**City of Ketchum
Planning & Building**

**STAFF REPORT
KETCHUM CITY COUNCIL
MEETING OF APRIL 5, 2021**

PROJECT: Warm Springs Ranch

APPLICATION TYPES: Development and Rezoning Agreement, Large Block Preliminary Plat, and Block 1 Subdivision Preliminary Plat

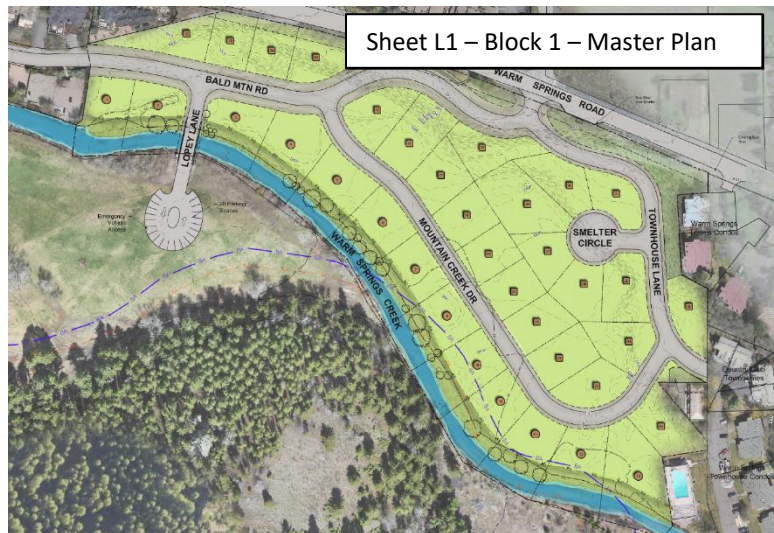
The applicant has requested waiver from certain street design and grading standards due to the site's topographical challenges. The applicant's waiver request and associated analysis is included as Attachment E to the Staff Report. Staff supports approving the applicant's waiver request because the project will improve the development's site circulation design, enhance safety, and expand pedestrian access.

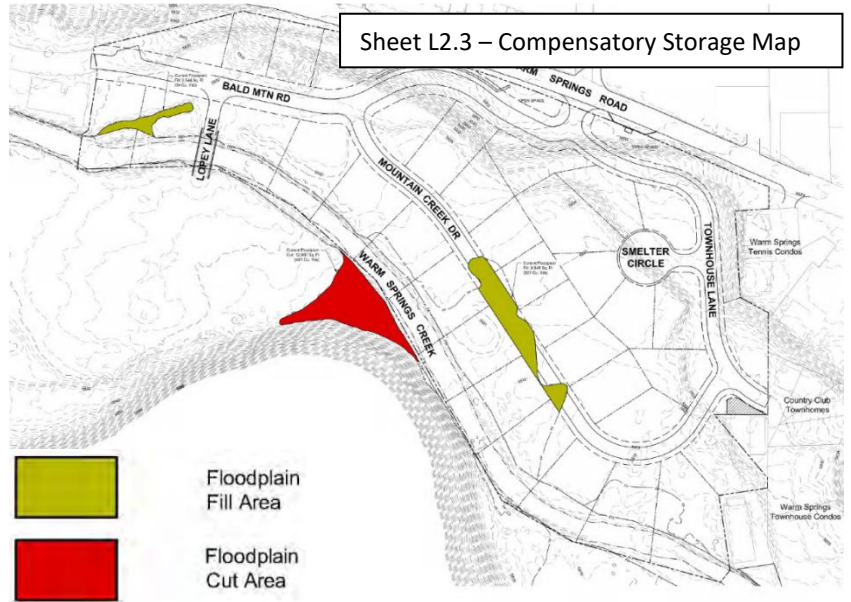
The fill proposed in the floodplain is proposed for two reasons: creation of suitable building sites and grading related to the construction of Mountain Creek Drive. There are two (2) lots, Lots 1 and 2, which are located on the upstream (western) side of the existing bridge that would be unbuildable without the addition of fill. These two lots are traversed by a manmade, historic irrigation ditch that is no longer in use. Fill in the amount of 94 cubic yards is needed to level out these lots. For visualization purposes, a standard home oven (3' x 3' x 3') is approximately 1 cubic yard in volume.

To fill in changes in topography and grade the area of Mountain Creek Drive that traverses the floodplain 327 cubic yards of fill are required.

- Compensatory storage within the floodplain is required to offset the fill. In other words, an area or areas within the floodplain must be excavated in an amount equal to the fill being placed in the floodplain so that the floodplain’s carrying capacity is not diminished.
- FEMA must approve a Letter of Map Revision based on fill prior to the city’s issuance of a floodplain development permit that proposes fill in the floodplain.

The applicant has proposed to locate compensatory storage on the south side of Warm Springs Creek in an area that is not proposed for residential development, as indicated in the diagram above.

The applicant is pursuing its required permit for fill from FEMA and has not yet received FEMA’s approval. As such, staff recommends continuing the hearing on the floodplain application to a date certain.

The applicant can proceed with their Preliminary Plat approval. However, prior to adding fill within the floodplain, the city must issue its floodplain development permit. Similarly, because this scope of work includes restoration of the riparian zone, this permit must also be issued prior to work in the riparian zone.
